STEIN RESUBDIVISION SUBDIVISION

APPLICATION NUMBER 15 DATE December 15, 2005

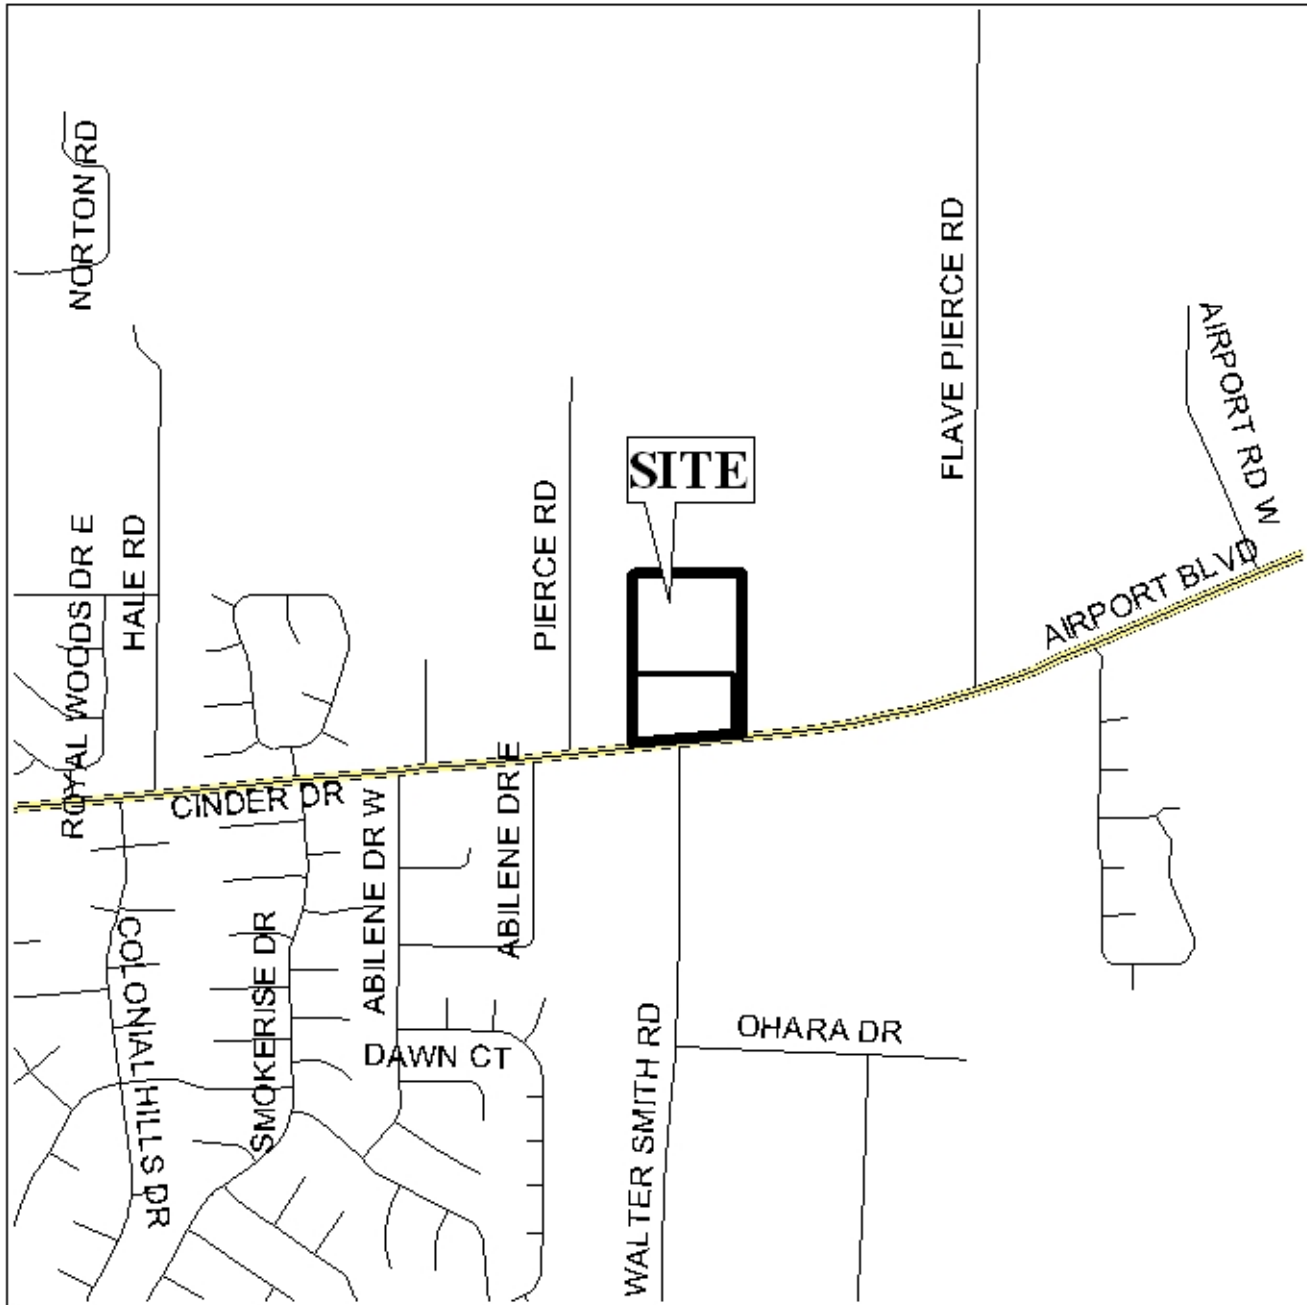
The plat illustrates the proposed 2 lot, 17.6 \pm acres subdivision which is located on the North side of Airport Boulevard, 380' \pm East of Pierce Road. The subdivision is served by public water and sanitary sewer.

The site fronts Airport Boulevard, a planned major street which has an existing right-of-way of 80-feet. As Airport Boulevard is a planned major street requiring a 100-foot right-of-way, the dedication of sufficient right-of-way to provide 50-feet from the centerline should be required. Additionally, as a means of access management, the placement of a note on the final plat stating that Lots 1 and 2 are limited to a total of four curb cuts to Airport Boulevard, with the size, location and design to be approved by County Engineering should be required.

As indicated on the plat, Lot 2 is flag-shaped. This is not uncommon for a commercial development. Additionally, should the lot be further subdivided, then adequate frontage is provided to access Airport Boulevard to allow for road construction.

This site is located in the County, thus a note should be placed on the final plat stating that any lots which are developed commercially and adjoin residentially developed property must provide a buffer, in compliance with Section V.A.7. of the Subdivision Regulations.

The plat meets the minimum requirements of the Subdivision Regulations and is recommended for Tentative Approval subject to the following conditions: 1) the dedication of sufficient right-of-way to provide 50-feet from the centerline of Airport Boulevard; 2) the placement of a note on the final plat stating that Lots 1 and 2 are limited to a total of four curb cuts to Airport Boulevard, with the size, location and design to be approved by County Engineering; and 3) the placement of a note on the final plat stating that any property that is developed commercially and adjoins residentially developed property shall provide a buffer, in compliance with Section V.A.7. of the Subdivision Regulations.
